DESIGN EXCEPTION #DE28-03

RE: Request to Reduce Street and Right-of-way Widths at 2776 Hwy 50

RE: TEDS Exception No. 28-03, to Reduce Street & Right-of-Way Width at 2776 Hwy 50

Re: Proposed Meridian Park Commercial Subdivision

COMMERCIAL STREET SECTION

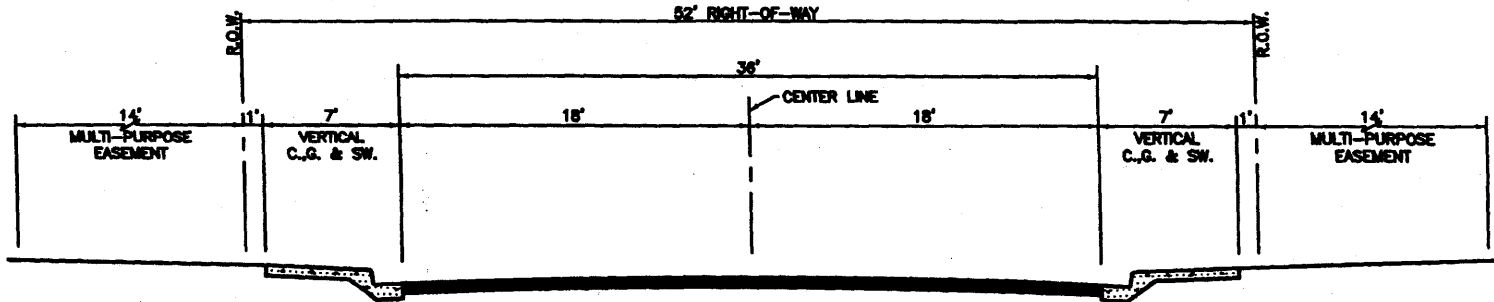
I could agree that there is little need for Collector Streets through this limited area. However, both corridors seem appropriate for standard Commercial Street sections. These will provide bike lanes and sidewalks like any other commercial development.

I recommend denial of the requested Design Exceptions to Section 6.1.1 to allow the proposed elimination of the sidewalk along one side and reduction of the pavement width for these streets. The committee might consider any or all of the other options mentioned above, or other(s) the committee might think of, as a modified approval.

* WOULD ALLOW FOR THE REMOVAL OF THE ON-STREET BIKE LANES IF THEY CONSTRUCT ADEQUATE BIKE/PEDESTRIAN TRAIL ON BOTH SIDES OF THE STREET. OTHERWISE, BIKE LANES & SIDEWALKS ARE REQUIRED ON BOTH SIDES OF THE STREET.

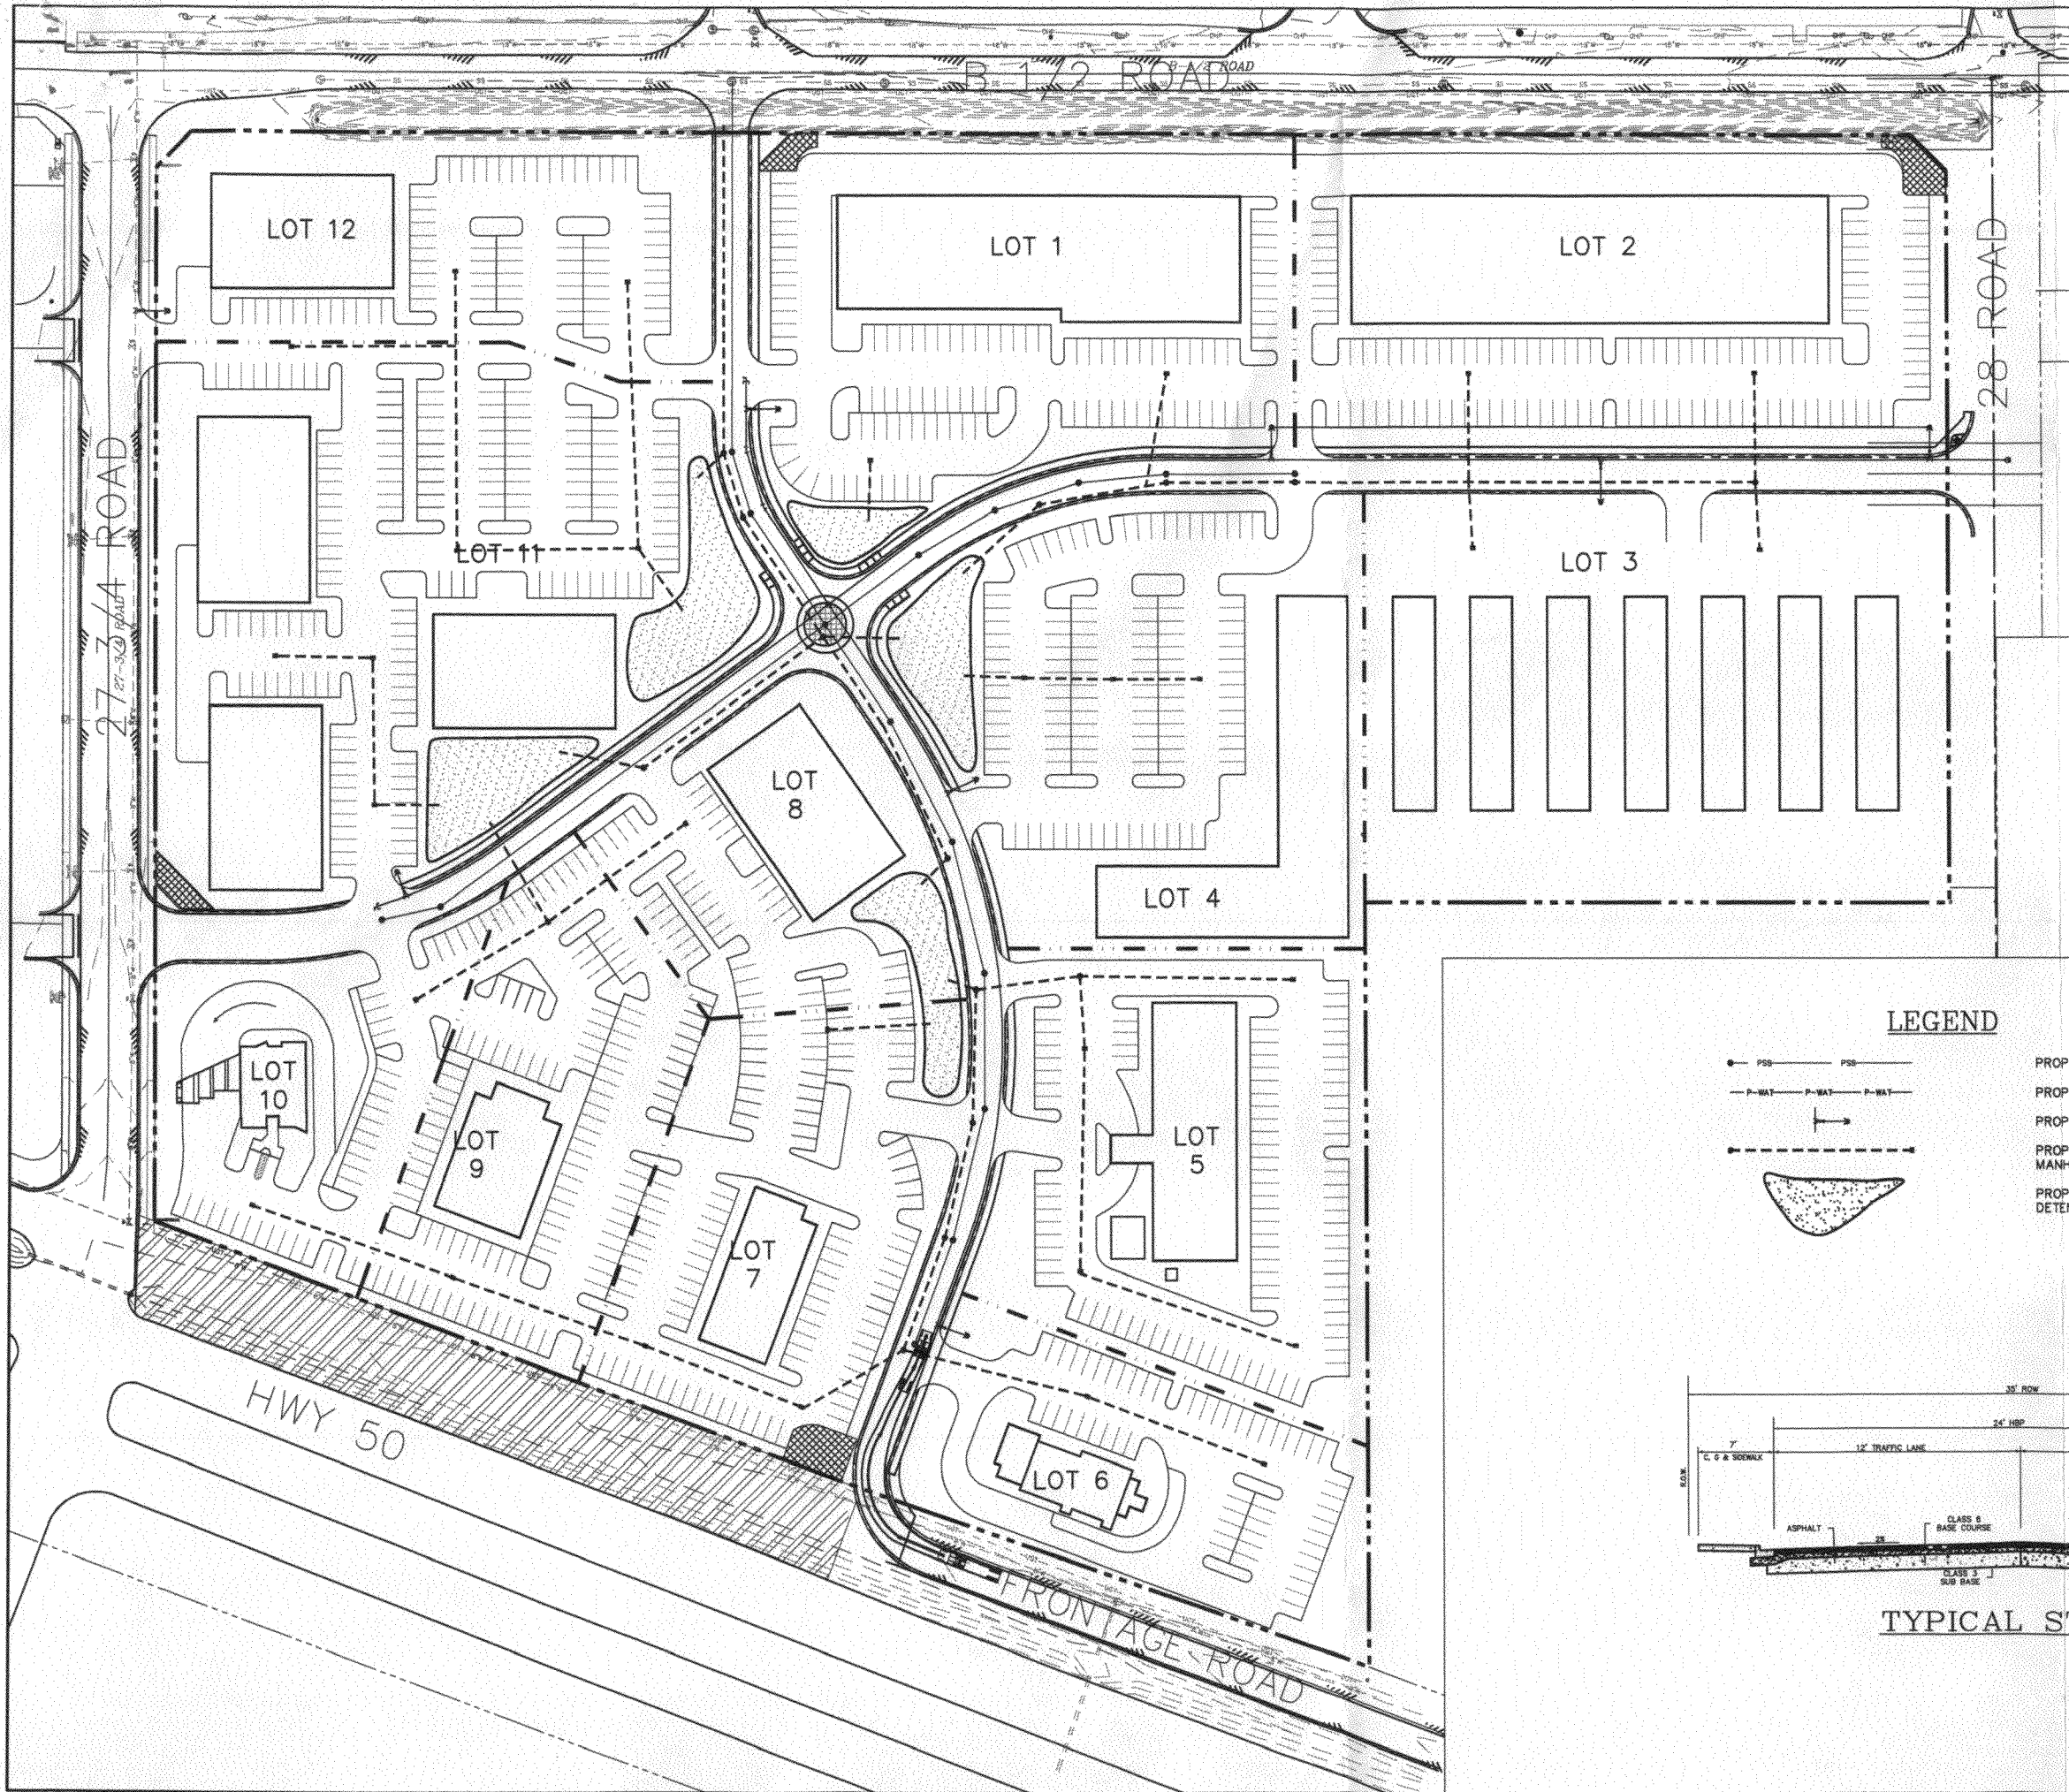
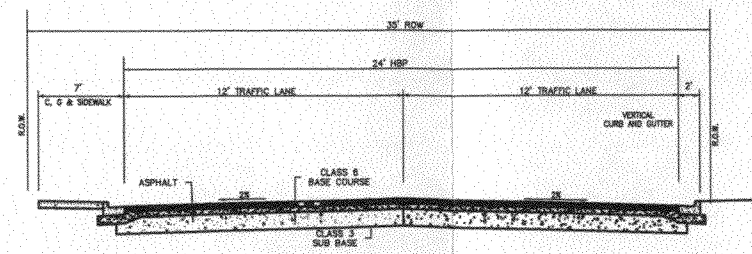
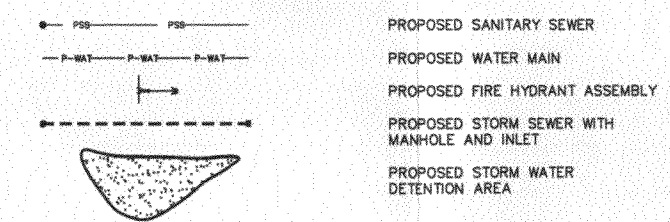
This plan gives very little consideration to pedestrian and bicycle traffic within and through the development. Only the barest accommodation is provided for the properties to the east along the Frontage Road. As Jody points out, the project claims trip generation credit for saved trips within the development, but fails to recognize those trips with adequate facilities in this plan. Both of these streets appear to be attractive options for non-motorized trips between B1/2 Road and the highway.

- We should not approve the proposal to install sidewalk on only one side of the street, unless the developer provides equivalent "private" pedestrian circulation facilities that run essentially parallel to the street alignment within appropriate easements. As I understand it, the single walk was approved at GMC because one side of the street fronts onto the backs of some existing lots, and will not likely have any need for pedestrian facilities.

The request for the exception does not adequately explain the need to reduce the street pavement section, other than to assert that they believe on-street parking is improbable, but there is no quantitative data supplied, such as the number of code-required spaces and how the plan meets or in this case even exceeds that requirement.

Based on the proposed site plan, this is a very mixed use site, unlike the Grand Mesa Center. The traffic study, currently under review, takes a 20% trip credit based on the fact that there are related businesses for which internal trips can be claimed. The site includes office, retail, restaurants, storage and a hotel. It is likely and probable that there will and should be pedestrian activity within the site as people interact between the uses. The lack of sidewalks will not promote the intended pedestrian use within the site and does not meet the intent of the adopted current street cross-section.

I have reviewed DE28-03 Request to Reduce Street and Right-of-Way Widths at 2776 HWY 50. I concur with Mike McDill's recommendation of denial. I see no basis to have sidewalk on only one side of the streets; and adequate width for bike lanes, where required, should also be provided. I do agree, however, that on-street parking is likely not needed given the amount of on-site parking shown and the placement of the buildings away from the street frontages.

** WOULD ALSO CONSIDER A NARROW STREET SECTION (e.g. 24') WHERE LEFT TURNING MOVEMENTS WOULD NOT NEED TO BE ACCOMMODATED. WOULD REQUIRE SUBMITTAL OF ENGINEERING ANALYSIS.
